Shamser Knit Fashions Ltd. (Unit-2) Extension

Sreepur Bus stand, Ganakbari, Savar, Dhaka

24 September 2025

2. Observation:

Observation-04: Lack of design documents, geotechnical investigation report, material test report, & load plan. (RCC Building 2)

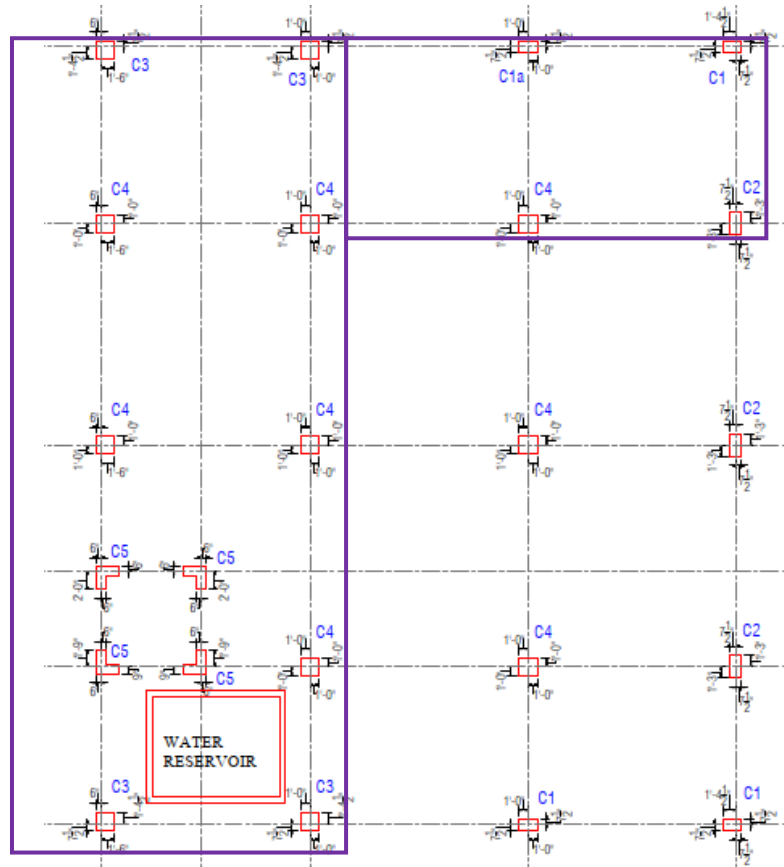
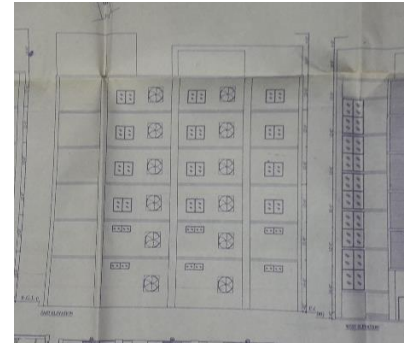
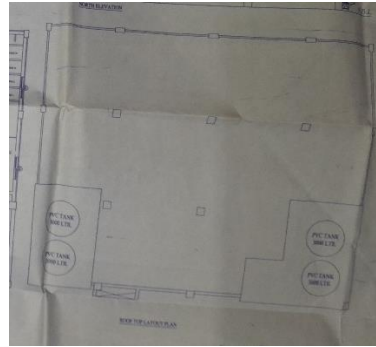
Description: Design report, geotechnical investigation report, material test reports & load plan were not available during the inspection. The factory is required to prepare a design report following BNBC 1.9.1, verify in situ concrete strength by taking 100 mm diameter concrete cores from the structural members (Column, Beam-Slab), and prepare a load plan considering the structural member capacity.

Observation-06: Marginal column stress & unauthorized extension on the roof (RCC Building 2)

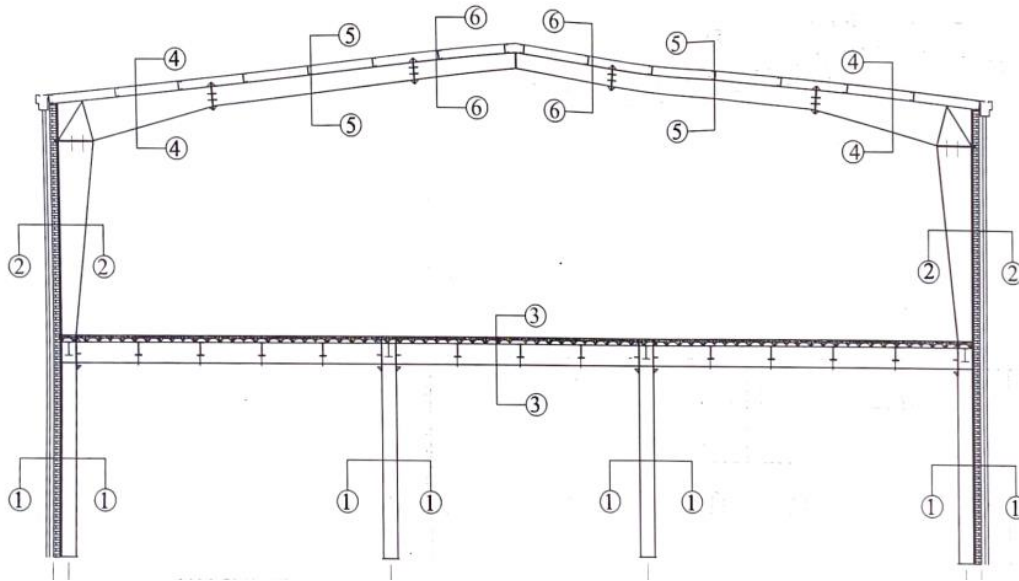
Description: cursory calculation indicated that columns are stressed above the normal design limit in the extension part of the building.

As per the local authority's approval, building permits were issued for a six-story structure. However, the factory has constructed partial extensions on the roof. The Building Engineer is required to obtain revised approval for updated layout drawings reflecting these extensions.
